Office Action Summary

10/077,927

NAKAMINAMI ET AL.

DETAILED ACTION

FIG. 3

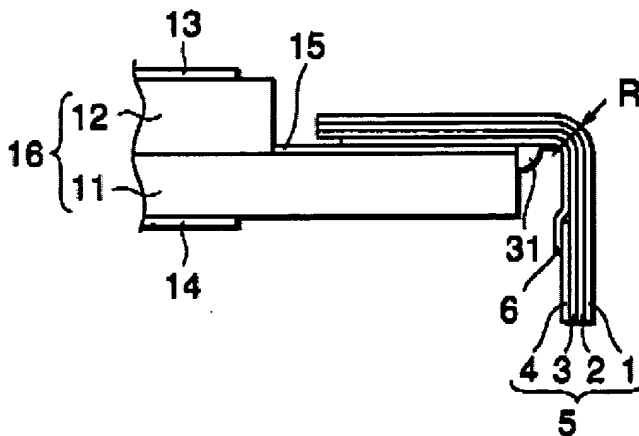
11. Nakamura discloses (col. 1, line 58 – col. 2, line 22) and shows in Fig. 3, a display module, which includes a display panel (16) provided with external connection terminals and a flexible wire board (5) having a wire pattern (3) on a base material (1),

terminals of the wire pattern of the flexible wire board and the external connection terminals of the display panel being bonded using an anisotropic conductive adhesive (6), the flexible wire board (5) having an insulating protective layer (4) for protecting the wire pattern.

Nakamura only shows that the protective layer is extended through one side of the edge of the display panel in a width direction of the flexible wire board but differs from the claimed invention because he does not explicitly disclose that the insulating

protective layer of the flexible wire board is extended inside the display panel through both sides of the edge of the display panels in a width direction of the flexible wire board.

As to claims 3, 4 and 13-16, Nakamura clearly shows in Fig. 3 that the anisotropic conductive adhesive (6) is extended to protrude from the display panel (16). Nakamura also discloses that the base film (1) of the flexible wire board has a thickness of 25 μm (not more than 40, and the insulating protective layer (4) has a thickness of 25 μm (not more than 40 μm), and the insulating protective layer is bonded onto the base material including the wire pattern (3) by thermocompression bonding (col. 4, lines 29-37; 52-54).

As to claims 5 and 6, Nakamura also shows in Fig. 3 that a corner of the display panel (16), which faces an inner side of a bent portion of the flexible wire board (5) in a bent state, is formed into a chamfered portion. Further, as explained above since Fujita teaches that extending the insulating protective layer of the flexible wire board inside the display panel is advantageous since it prevents any short-circuiting from occurring to the leads due to the foreign objects adhering thereto and that the chamfered portion is formed at the periphery of the substrate of the display panel, it would have at least been obvious that the insulating protective layer of the flexible wire board is extended beyond the chamfered portion.

As to claims 7-9, Nakamura also shows in Fig. 3 that the flexible wire board (5) is also bonded onto the chamfered portion and a side of the display panel by using anisotropic conductive adhesive (31).

Fig. 3D

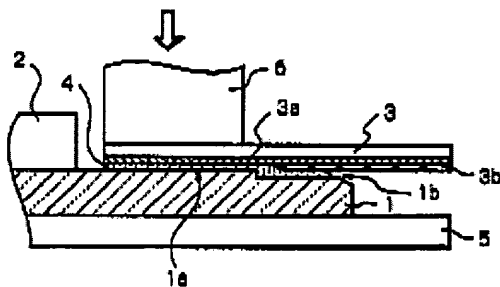
Fujita discloses a display module which includes a display panel (2) and a flexible wire board (3) having a wire pattern (3a) and an insulating protecting layer (3b) for protecting the wire pattern wherein the insulating protective layer extends inside the display panel (Fig. 3D). Fujita also discloses that since the insulating protecting layer extends inside the display panel and thus protect the leads of the flexible wire board from being exposed to outside, any short-circuiting can be reliably prevented from occurring to the leads due to the foreign objects adhering thereto (col. 3, lines 20-30; col. 4, lines 6-11; col. 5, lines 59-63).

Fujita is evidence that ordinary workers in the art would find a reason, suggestion or motivation to extend the insulating protective layer inside the display panel.

Therefore, it would have been obvious to one of ordinary skill in the art at the time of the invention was made to modify the display module of Nakamura by extending the insulating protective layer of the flexible wire board inside the display panel so that

the protective layer is extended through both sides of the edge of the display panel in a width direction of the flexible wire board for advantages such as protecting the lead of the flexible wire board from being exposed to the outside and thus reliably preventing any short-circuiting from occurring to the leads due to the foreign objects adhering thereto, as per the teachings of Fujita.
